Portland General Electric

Re: LC 80 – Portland General Electric Company’s 2023 Clean Energy Plan and Integrated Resource Plan Response to Initial Comments

Figure 1. Price Impact difference between Zero Additional EE and 50 MWa of additional EE

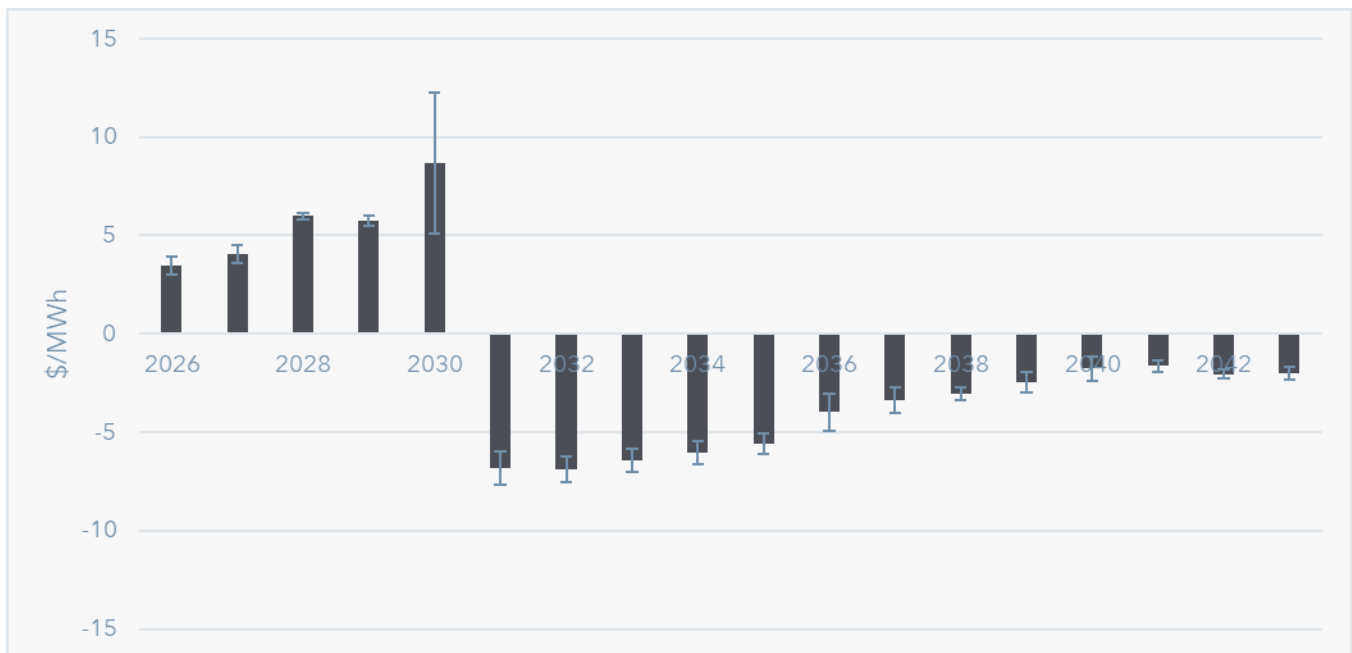
On the topic of how PGE approached and decided on the actions impacting energy efficiency (EE) and demand response (DR), Staff asked about how PGE’s modeling addressed direction from HB 2021 to consider EE DR resources in addition to non-emitting resources.³² Regarding not including additional EE in the Preferred Portfolio, Staff asked why PGE prioritized short-term cost impacts over long-term reductions and requested additional details on execution risk mentioned.³³ Staff also asked how PGE considered Senate Bill 1547 (ORS 757.054(3)) deciding on the role of additional EE.³⁴ Lastly, Staff asked for justification for not including additional EE in the Preferred Portfolio.³⁵

PGE notes that portfolio analysis found that when considering transmission constraints, EE can lower portfolio cost and risk. This finding, which highlights the potential benefits that EE can provide in alleviating transmission needs, is discussed in Chapter 12 Portfolio Analysis. That the Optimized EE portfolio selected 53 MWa of additional EE suggests that offsetting transmission need with up to 53 MWa of additional EE could reduce long-run portfolio costs.

Figure 1 highlights the difference in price impact between a portfolio with Zero addition EE and 50 MWa of additional EE. The 2030 impact would be \$9/MWh higher on average than the portfolio with zero additional EE. This translates to ~10% in the costs associated with generation resources relative to a portfolio without additional EE. Relative to 2024, in 2030 the 50 MWa EE portfolio is sees ~19% higher costs associated with generation resources relative to an ~8% increase in costs associated with generation resources for the portfolio with no additional EE.

Figure 2. The cyclical planning interaction between PGE and Energy Trust

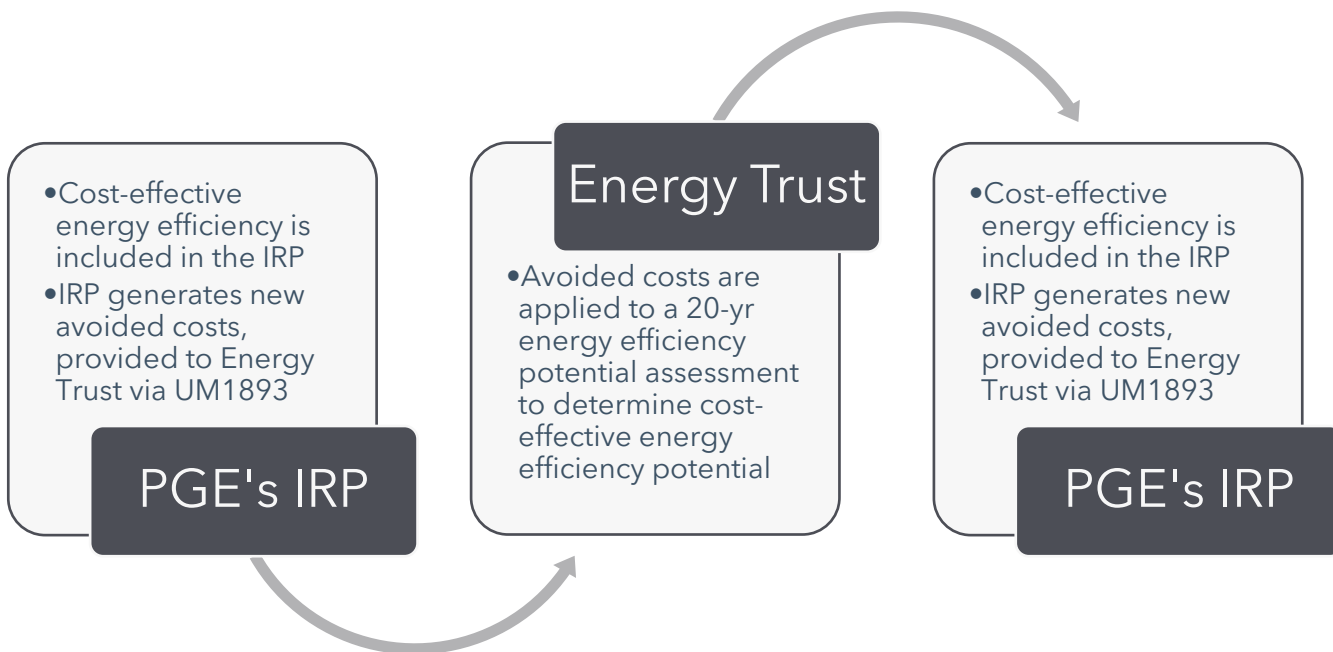
On the topic of Customer Actions, Staff ask if there is a discrepancy in the CEP/IRP since the Action Plan does not include non-cost-effective DR resources even though PGE’s CEP/IRP states that “...the IRP

The cyclical planning interaction between Energy Trust and PGE is shown in **Figure 2**.

Energy Trust’s role as statewide EE program administrator is to steward PGE customer dollars to realize savings for industrial, agricultural, commercial, and residential customers. The majority of PGE customer dollars that contribute to Energy Trust’s annual budget are ultimately provided to customers in the form of incentives. PGE supports Energy Trust via promotion (marketing and outreach funded from SB 838) and via Action Plan collaboration. Comprehensive Action Plans breakdown activities by customer program segment, Existing Buildings, Industrial & Agricultural, Residential, New Buildings, and Northwest Energy Efficiency Alliance (NEEA) funding, and support conservation measures including space and water heating and cooling, insulation, lighting, variable frequency drives, motors, refrigeration, wastewater treatment and custom incentives and strategic energy management as well as early design assistance and make-ready infrastructure. Utility-specific Action Plans, born out of House Bill (HB) 3141, go a step further to represent areas of joint investment and coordinate activity and are supported by workgroups – Community Engagement, Marketing and Outreach, Renewables, and Non-Wires Solutions - comprised of Energy Trust and PGE staff with charters that clearly articulate objectives and milestones.
